APPLICATION NUMBER 02-0046
OWNER/APPLICANT: Hanson Aggregates Mid-Pacific (Hanson)
APN: 067-011-07; 067-021-21& -22

SUBJECT: Continued Public Hearing on Application for Mining Approval Amendment and Permit Review of Existing Mining Operation

STAFF REPORT TO THE PLANNING COMMISSION

Figure 2
Basin Depth-Area-Volume Curves
(adapted from values provided by Bowman & Williams, 2003)

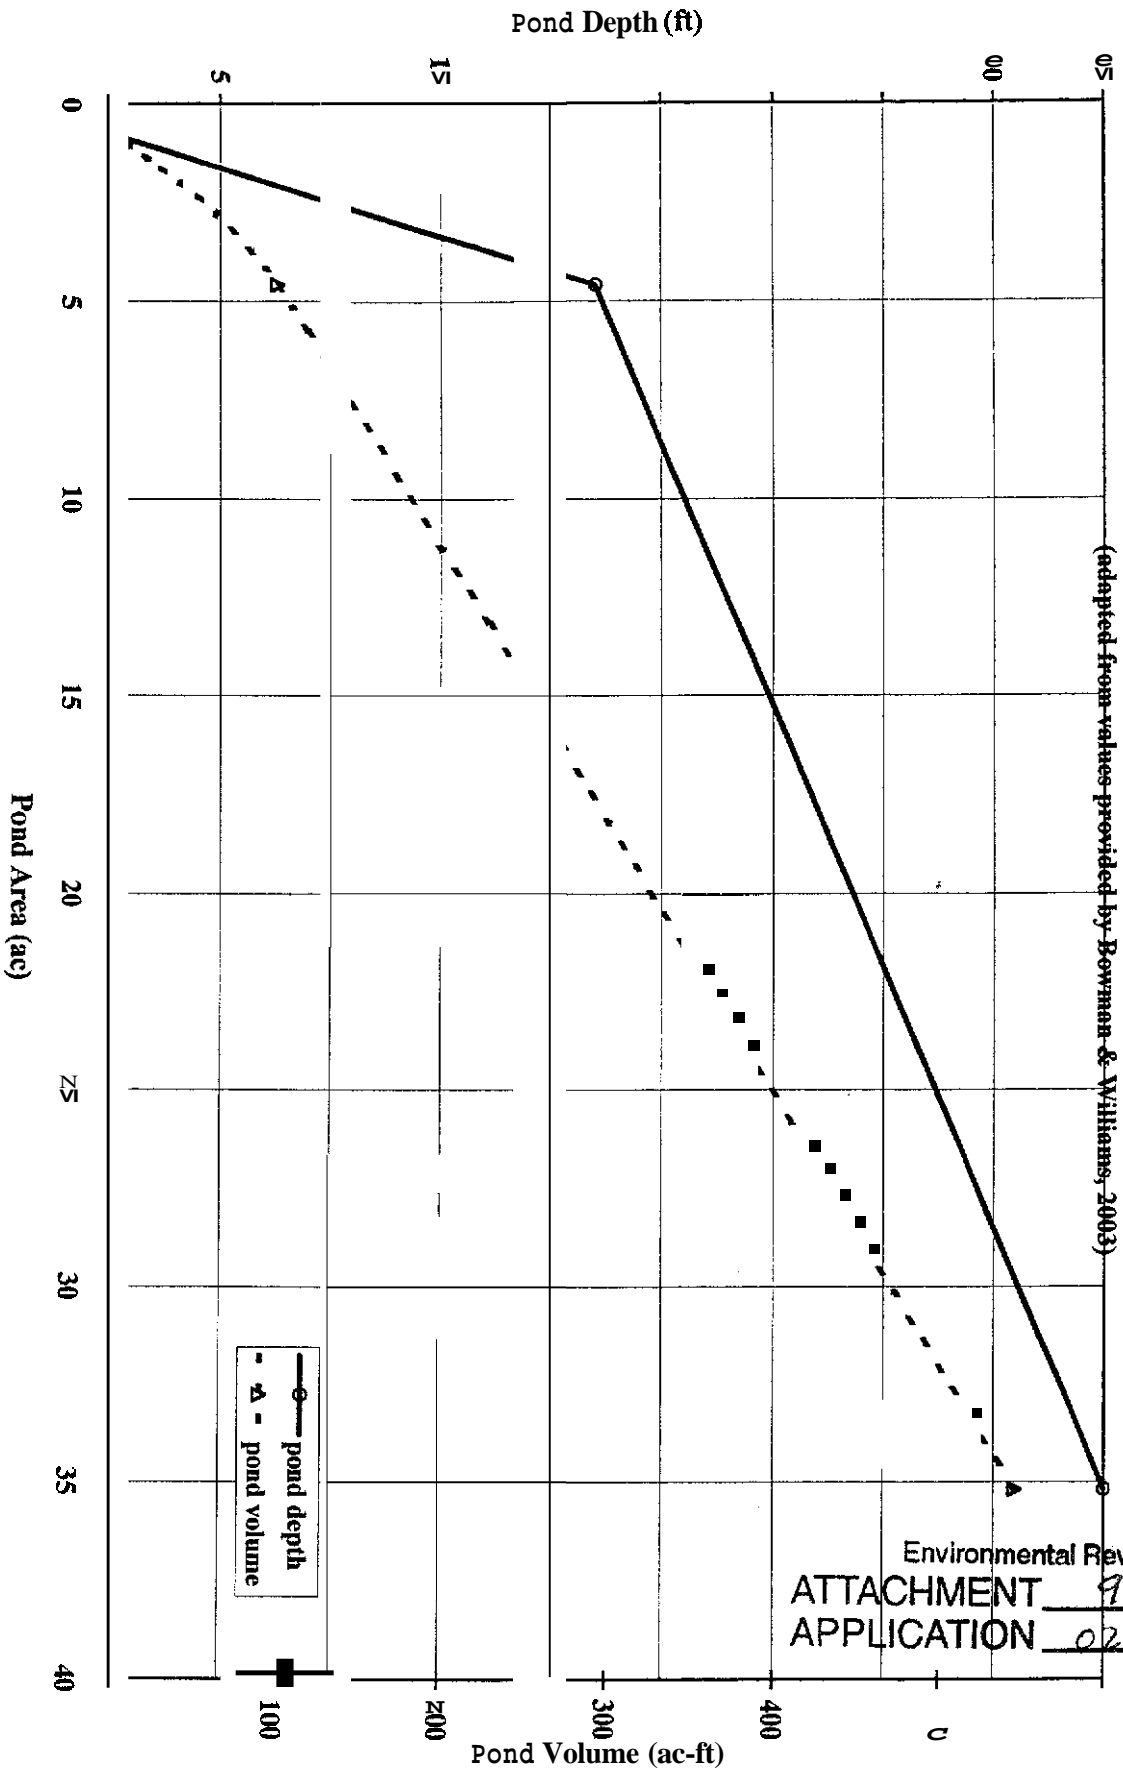
The proposed retention basin has a maximum depth of 45 feet. As shown in Figure 2, the water depth increases rapidly as the basin fills. It is reasonable to expect that such conditions will lead to accelerated clogging and problematic maintenance.
